**PLANNING BOARD
-REVISED AGENDA-
BRUNSWICK TOWN HALL
85 UNION STREET
COUNCIL CHAMBERS**

DRAFT FINDINGS OF FACT
Major Development Review
Final Subdivision Plan
Planning Board Meeting Date: October 13, 2015

Project Name: Meadow Rose Farm Subdivision
Case Number: 15-047
Tax Map: Map 17, Lot 126
Applicant: Two Clarks, LLC c/o Paul Clark
240 Main Street
Brunswick, Maine 04011

TITLE: **OVERALL SUBDIVISION PLAN AMENDMENT 1**

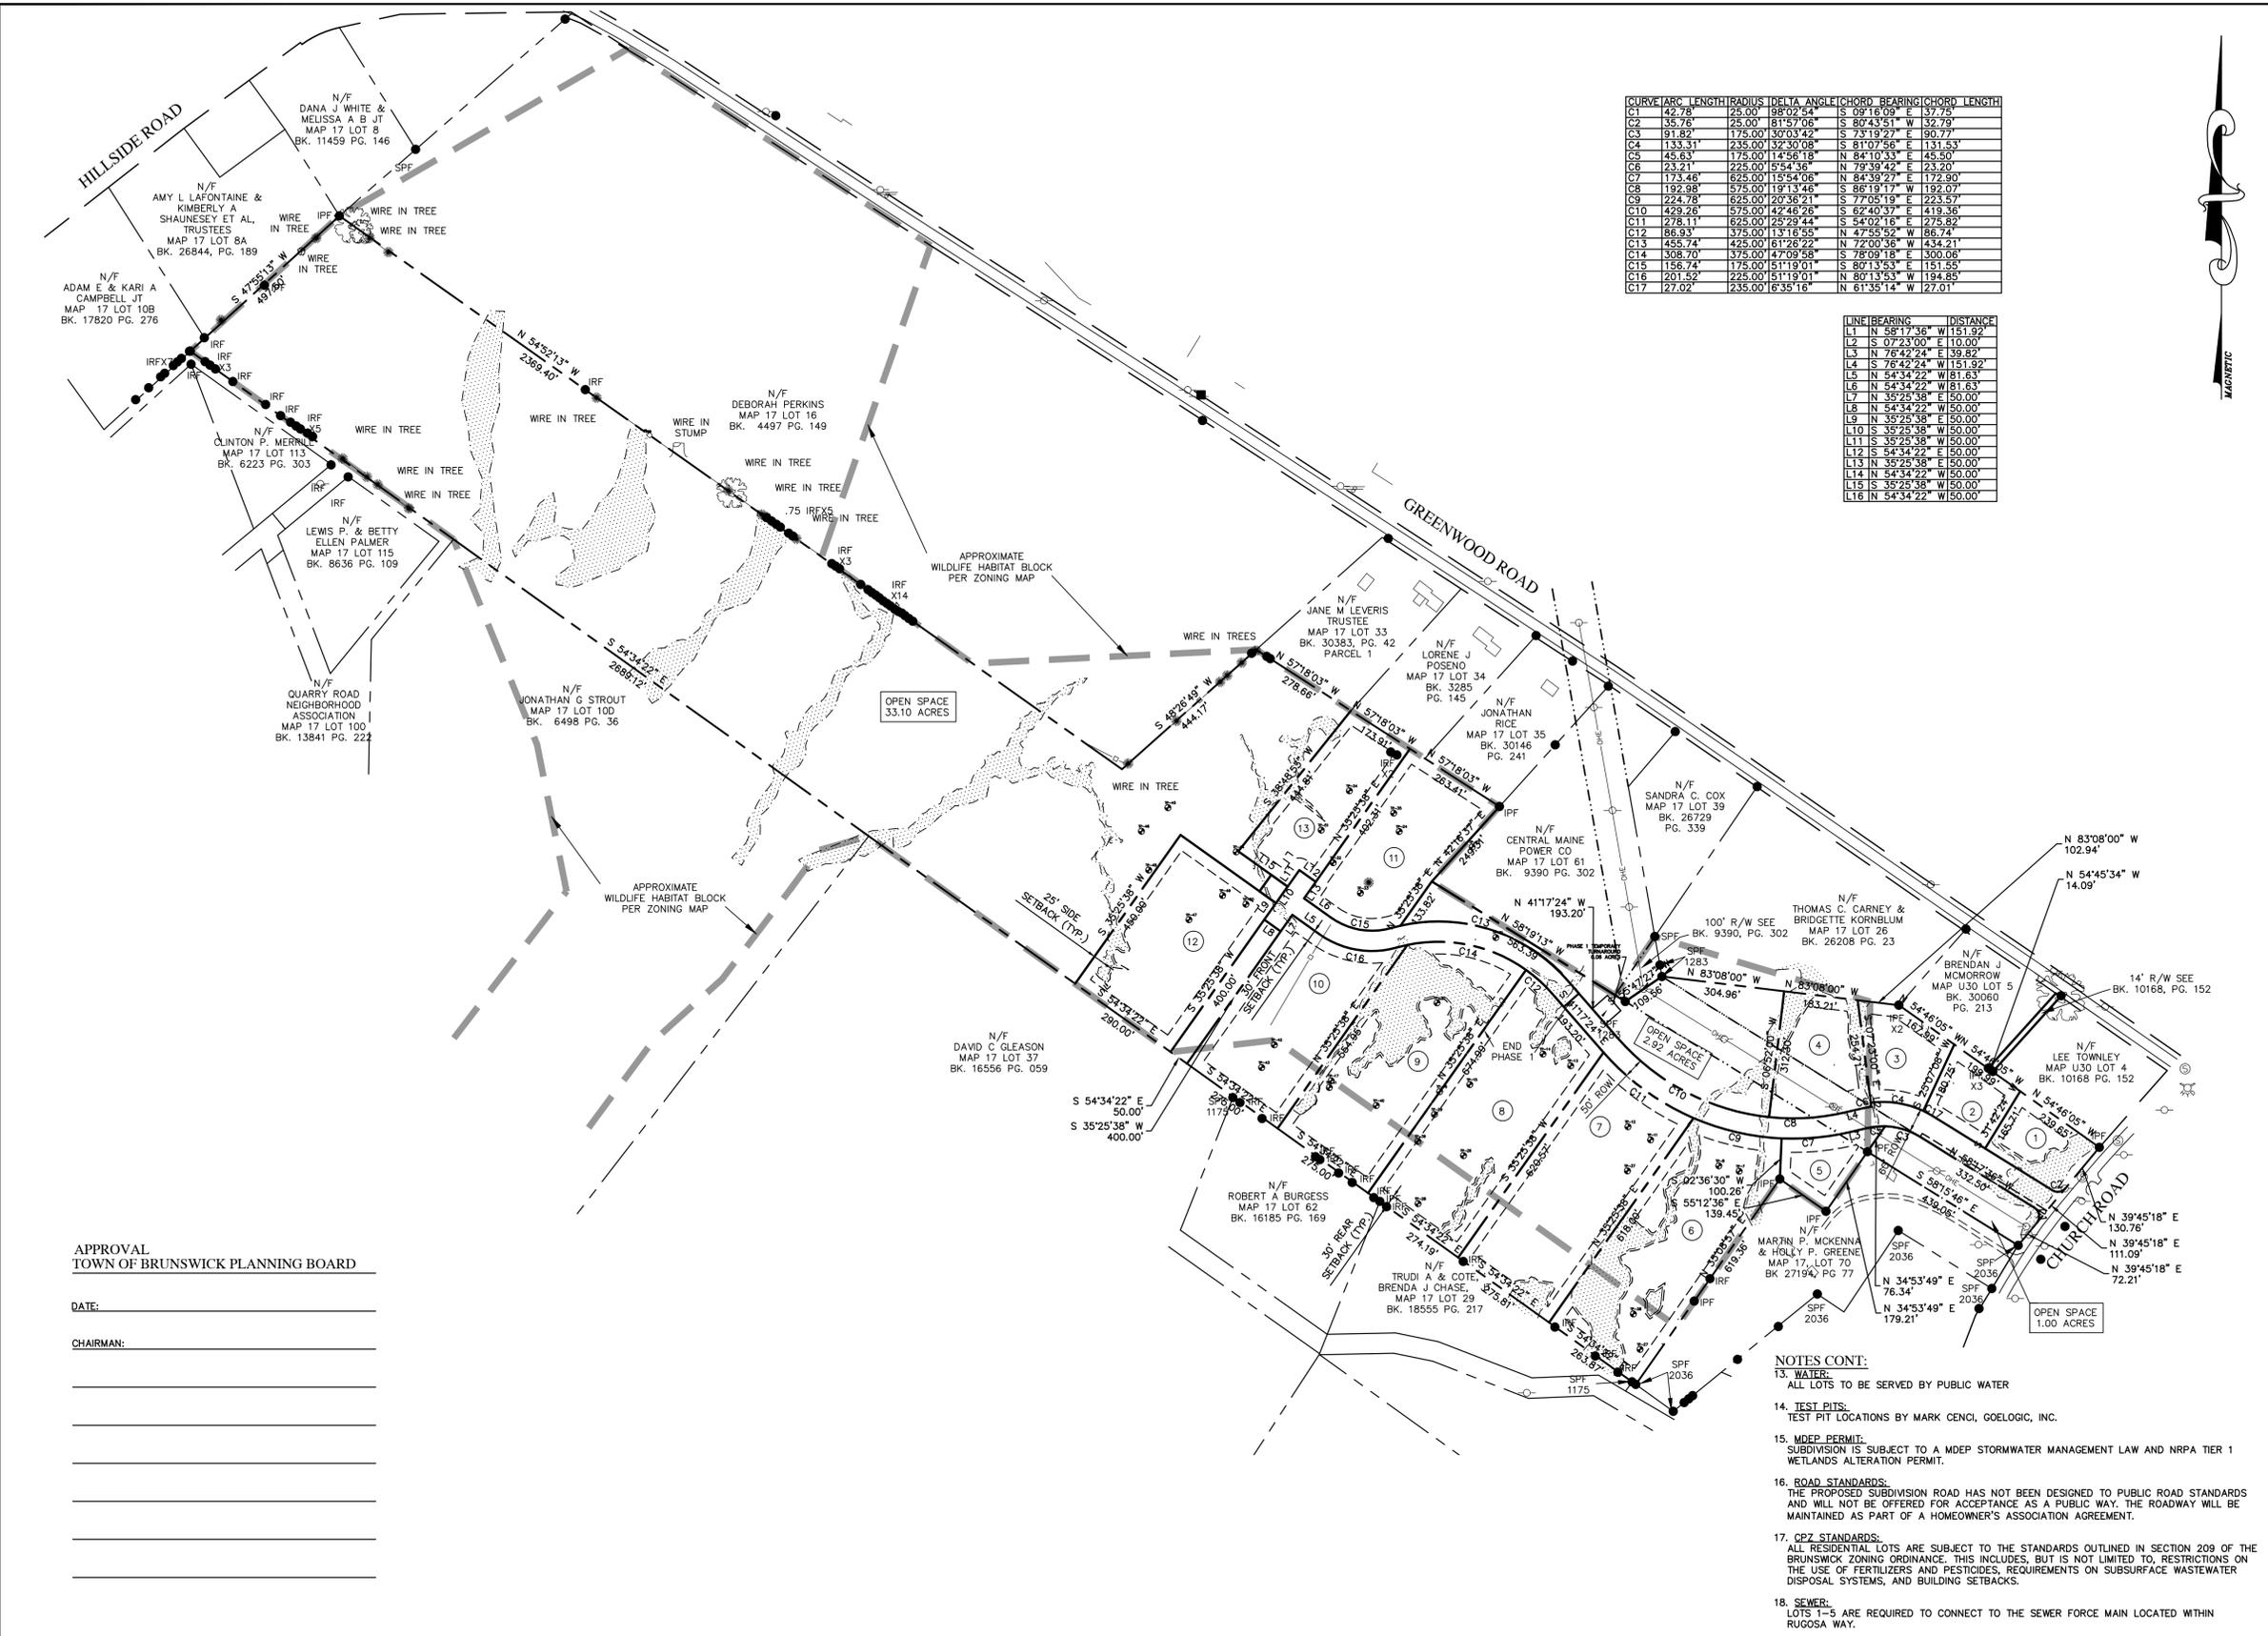
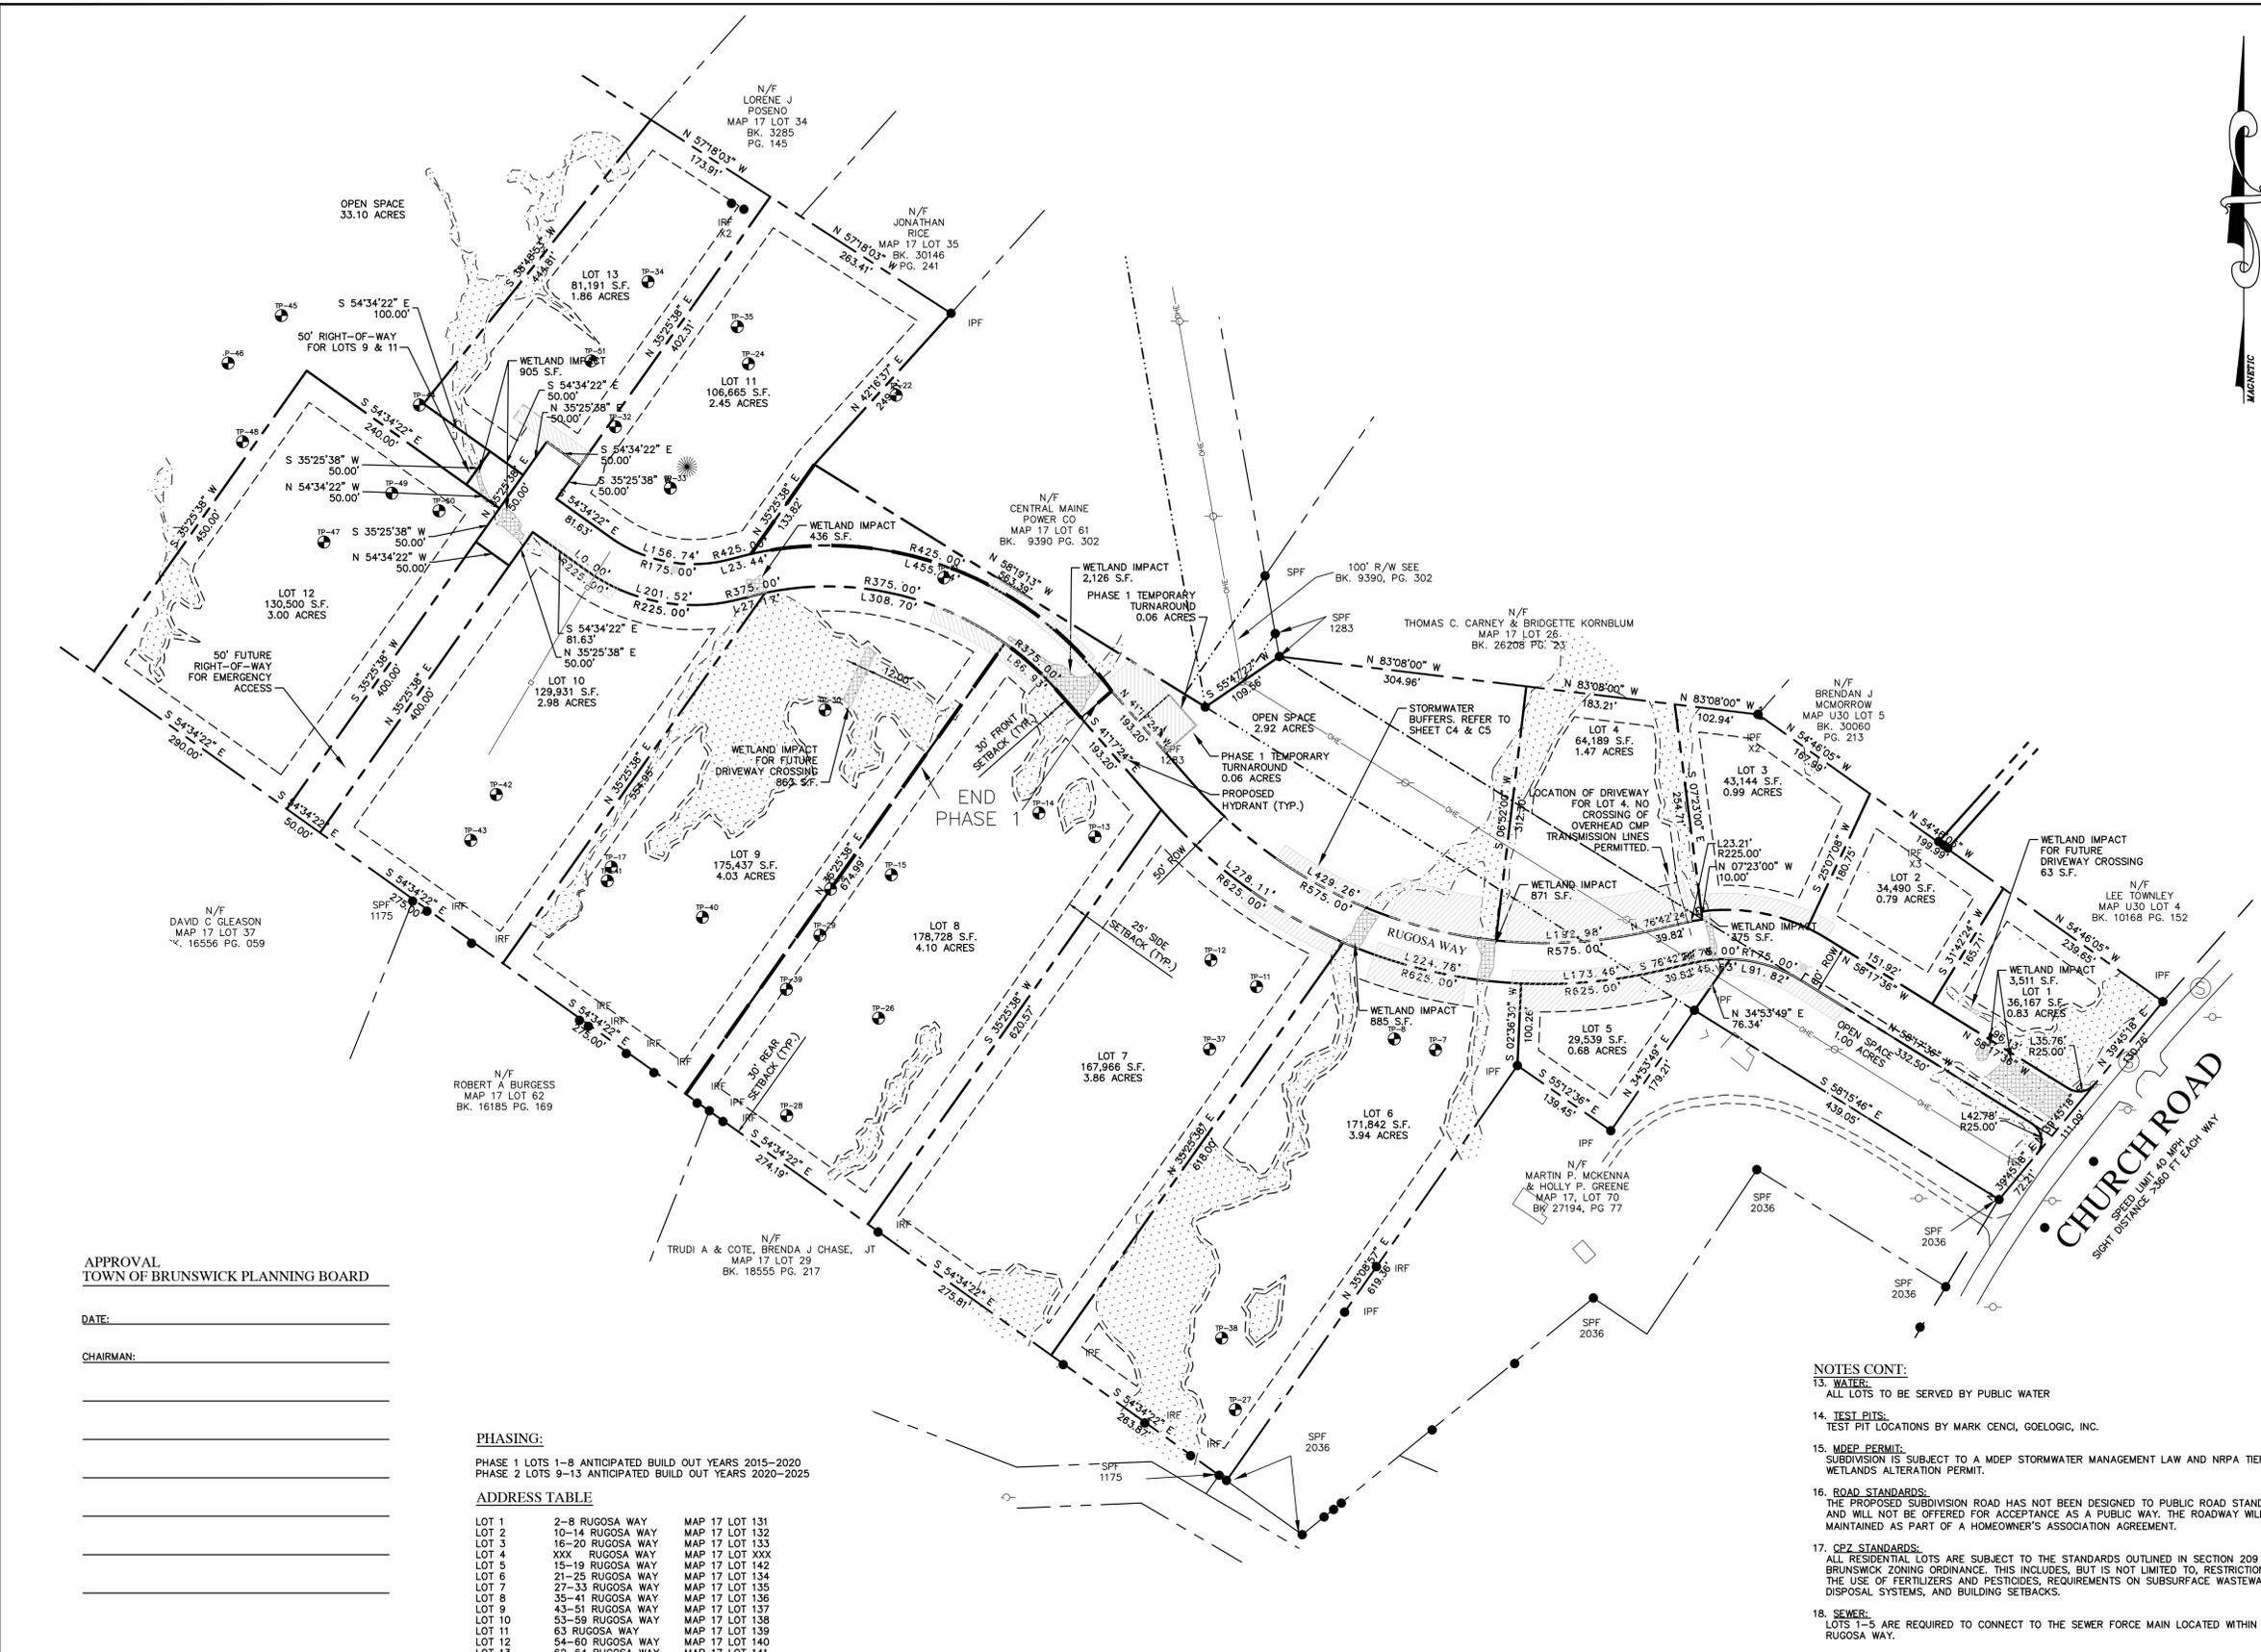
The proposed Amendment is in response to the proposed creation of one (1) new residential lot from the land area comprising existing Lot 1 and Lot 2, so-called; the installation of a new sewer line to serve the first five (5) lots from the entrance of Church Road; and the revision of

The proposed additional lot and associated change in lot area results in Lot 1 containing 0.83 acres, Lot 2 containing 0.79 acres, Lot 3 containing 0.99 acres and newly created Lot 13 will remain unchanged from its former designation as Lot 3.

Motion 2: That all applicable prior conditions relating to this amendment remain in effect, in addition to any new conditions contained herein with the exception of prior condition #8 which is revised as follows:

1. That prior to the issuance of a building permit the applicant shall record the proposed conservation parcel in the Cumberland County Registry of Deeds and provide a copy of the recorded conveyance to the Director of Planning and Development.
